**DOCUMENT 00 90 00**  
**ADDENDUM**

**ADDENDUM No.:** 1

**DATE:** April 1, 2024

**RE:** HOUSING AUTHORITY OF THE CITY OF LA CROSSE  
FOREST PARK EXTERIOR IMPROVEMENTS  
1230 BADGER STREET  
LA CROSSE, WISCONSIN 54601  
PROJECT NO. 23068

C050

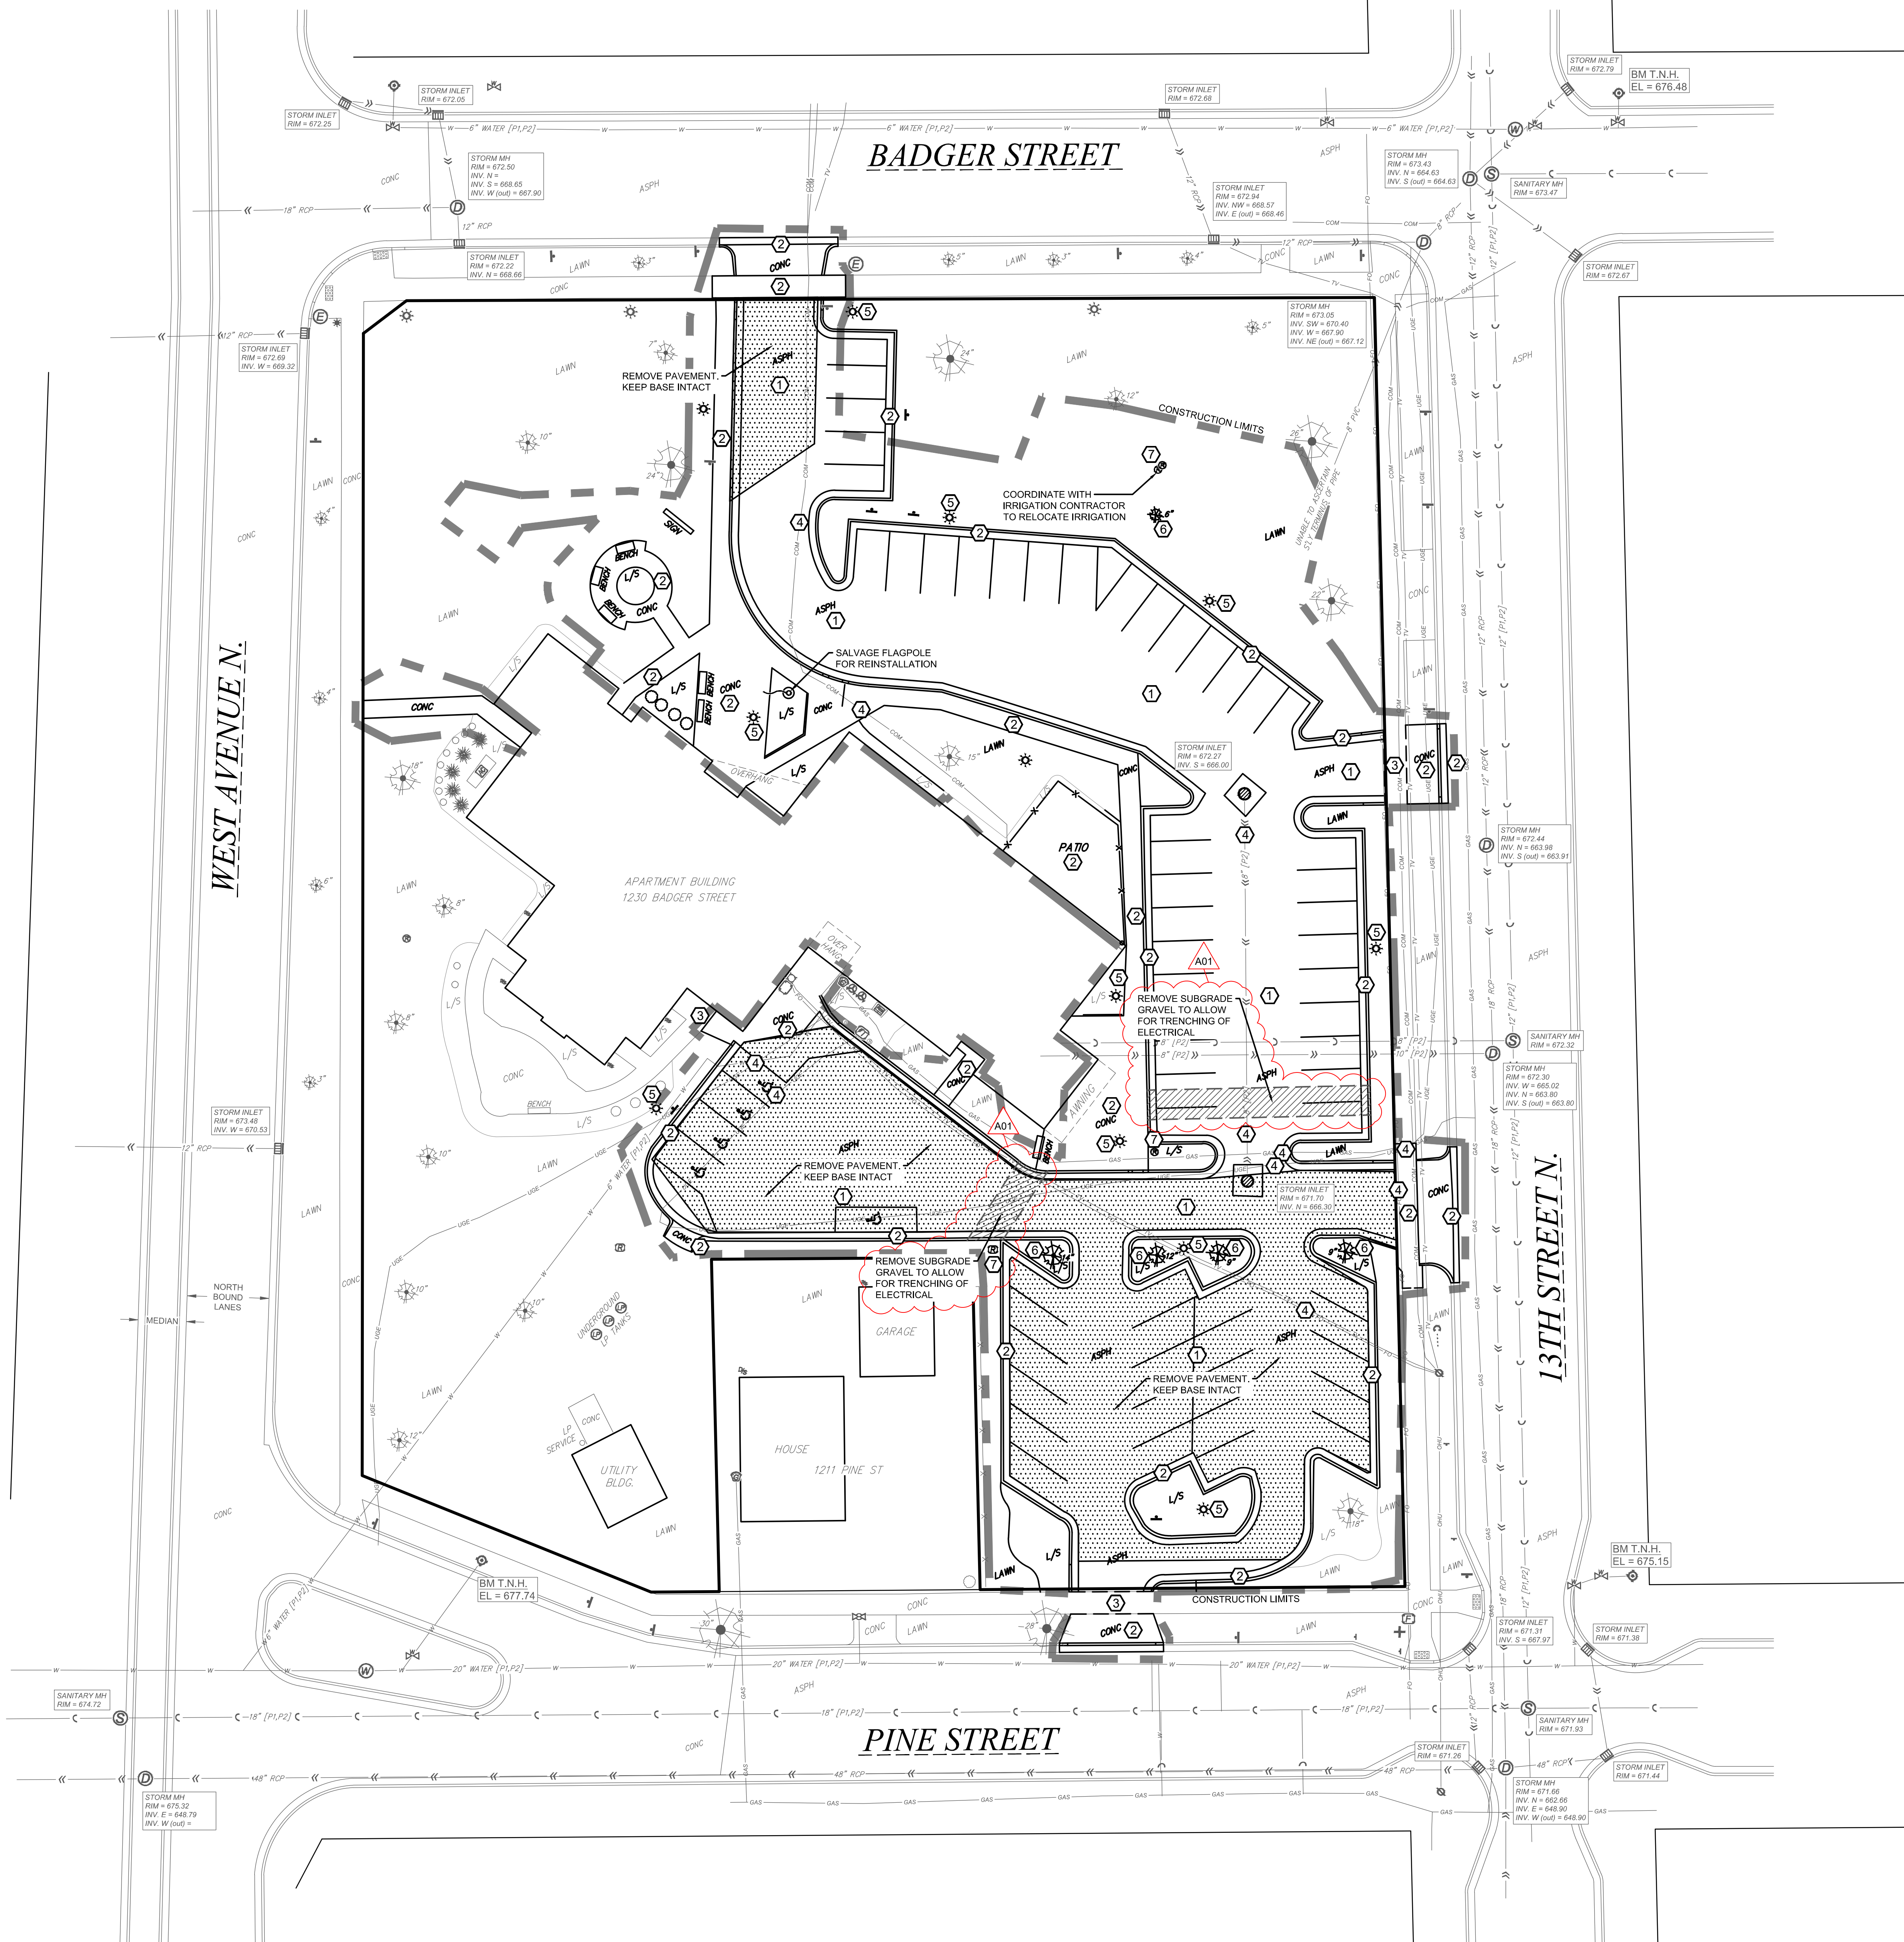
3. Sheet C050 DEMOLITION PLAN 30"x42"
  - a. See the revised sheet included in this addendum. Disregard the previous version.
  - b. Added locations and requirements for electrical trenches across paved areas.
4. Sheet C100 SITE PLAN 30"x42"
  - a. See the revised sheet included in this addendum. Disregard the previous version.
  - b. Added 48" fence.
5. Sheet L100 LANDSCAPE PLAN 30"x42"
  - a. See the revised sheet included in this addendum. Disregard the previous version.
  - b. Added plantings and associated landscaping.

**2** POLE DETAIL-TYPE OA3  
NTS

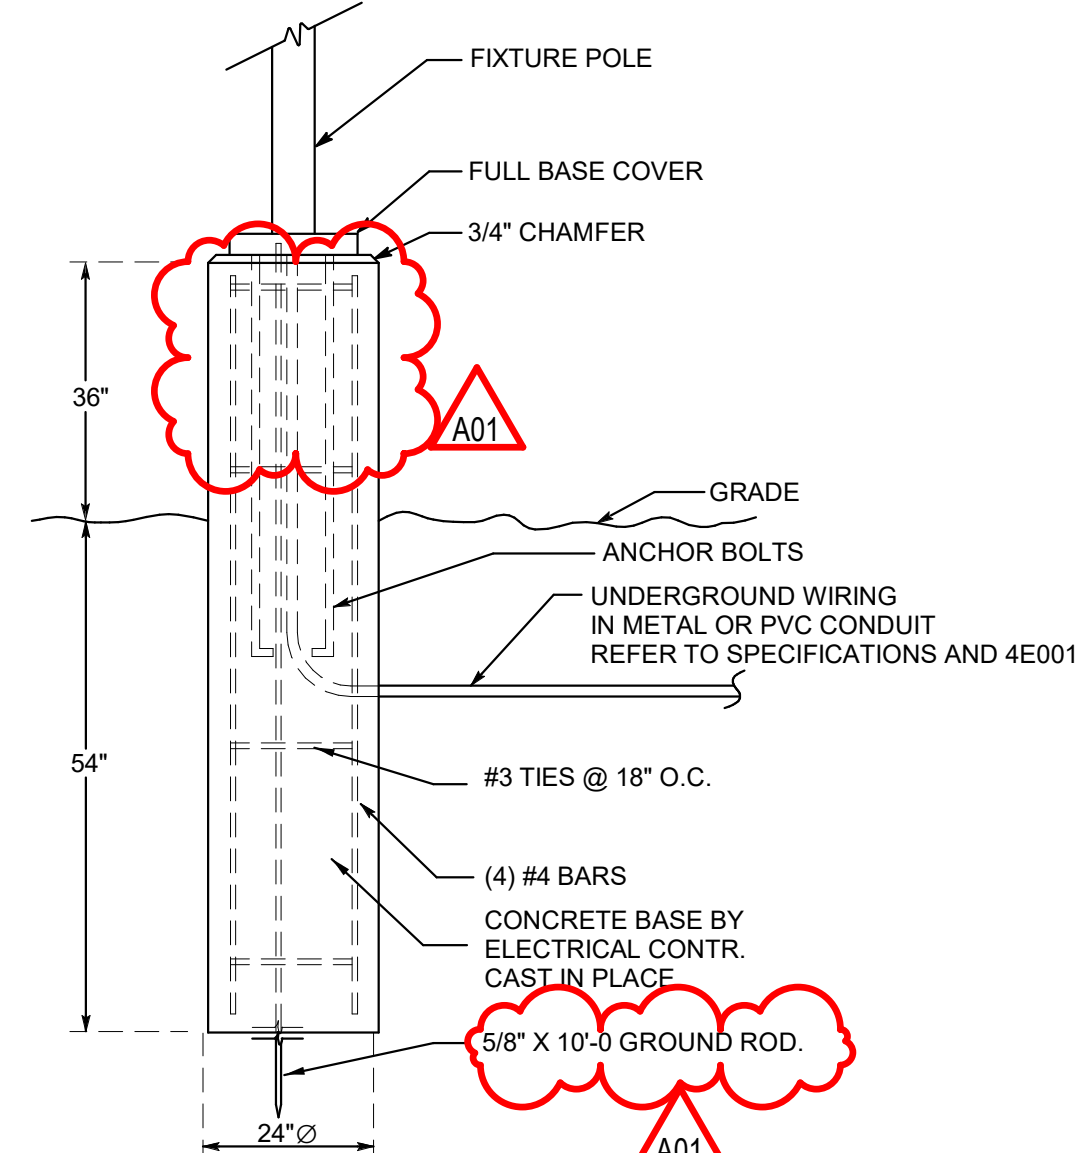
- a. See the revised sheet included in this addendum. Disregard the previous version.
- b. Plan 1/E002: revise lighting at south parking lot area.
- c. Specific notes : Added note #4.
- d. Pole base detail 2/E002: Extended RE-bar to top of pole base and changed ground rod to 10'.
- e. Pole base detail 3/E002: Changes ground rod to 8'.
- f. Revised light fixture schedule.
